# Access Compliance Report

## Public Rights-of-Way

| Intersection ID: 15956 | Main Street: POINDEXTER_DR | Cross Street: SEDGEFIELD_RD | Location: W            |
| ADA ID: 4405B98C2AA7   | Ramp Type: PerpDiag        | Initial Pass/Fail: Fail     | Overall Compliance: No |

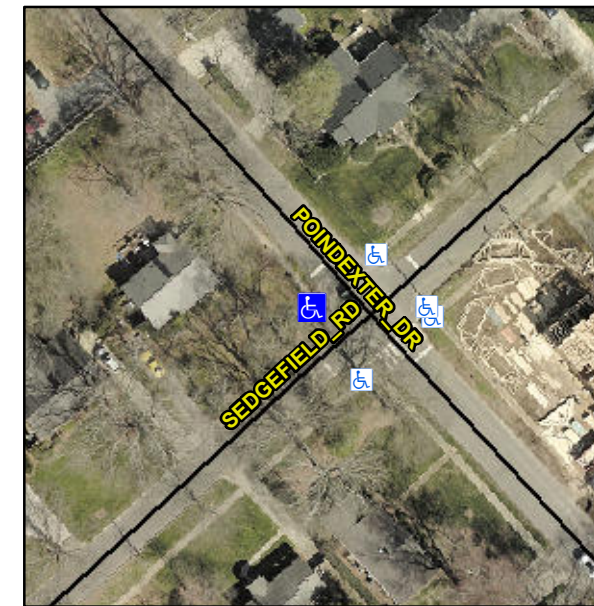
**Not Found, R304.5.1, R304.2.2, R304.5.3**

| Compliance | Description           | Data  | Compliance | Description                 | Data  |
|------------|-----------------------|-------|------------|-----------------------------|-------|
| N/A        | Ramp Length (in)      | 62.0  | No         | Ramp Slope (%)              | 10.5  |
| No         | Ramp Width (in)       | 47.0  | No         | Ramp XSlope (%)             | 4.5   |

**Remove & Replace Curb Ramp With Two New Directional Ramps or Equivalent.**
